DEVELOPMENT APPLICATION ASSESSMENT REPORT

Application Number:	DA2021/0961

Responsible Officer:	Thomas Prosser
Land to be developed (Address):	Lot 2 DP 509415, 1951 Pittwater Road BAYVIEW NSW 2104
Proposed Development:	Alterations and additions to a dwelling house including swimming pool
Zoning:	R2 Low Density Residential
Development Permissible:	Yes
Existing Use Rights:	Yes
Consent Authority:	Northern Beaches Council
Land and Environment Court Action:	No
Owner:	Tracey Carfi
Applicant:	Sean Clive Gartner

Photo 3: Taken from the rear of 52 Alexandra Crescent

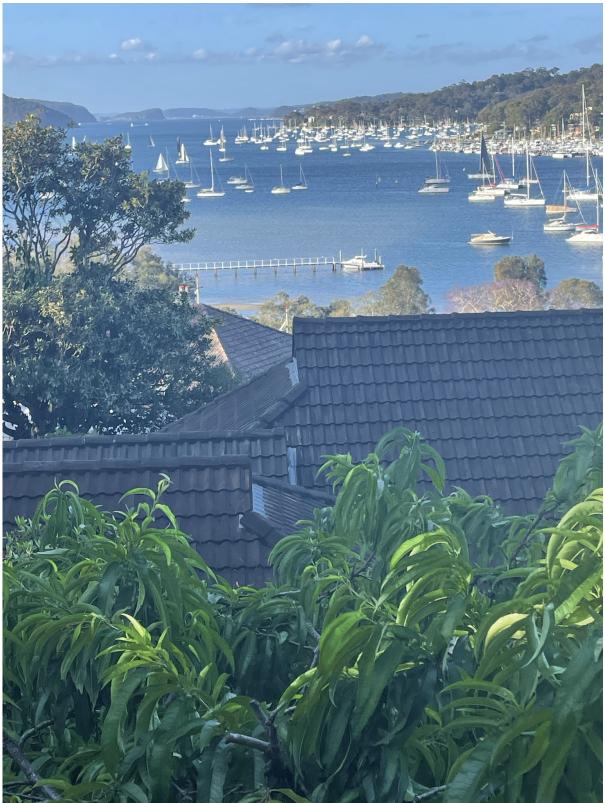
The view to be affected involves a small part of the water view of Pittwater from the rear of the property, and part of the foreshore area.

The views are obtained from living areas including a balcony at the rear of the dwelling. Views can be obtained form standing and sitting position.

The overall impact is considered to be negligible as a result of the extent of water view that would be retained.

The negligible impact and compliant building height provide a situation in which view sharing is reasonable.
